SANITARY WARE SPECIFICATION SHEET

**Approval of “AMERICAN STANDARD” Flush Valve
(General Acceptance No. C20230948F)**

Name of Manufacturer: Xiamen R&T Plumbing Technology Co Ltd
Country of Origin: the Mainland of China
Brand: American Standard
Details of Fitting: 3" Plastic dual flush valve
Model: PC-A242507
Body Markings: **R&T**
Expiry Date: 16 July 2028

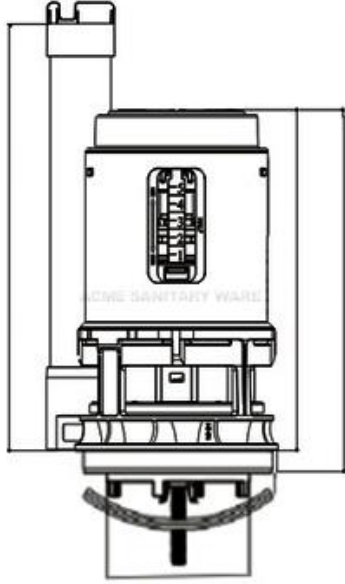
Proviso: As the fitting has not been tested for use in contact with water intended for human consumption, the fitting can only be used in flushing water plumbing system.

"The flushing volume of the flushing valve should be adjusted to suit the design of the toilet bowl so that wastes can be cleared effectively by a single flush."

"The fitting should be used within the range of working pressures specified by the manufacturer." AND

"The installed fitting should not result in backflow of water that will contaminate the flushing water supply."

This Authority hereby permits the use of the above fitting in flushing water plumbing systems subject to full adherence to Waterworks installation requirements. In particular, you are required to draw your customers' attention to the following requirement-
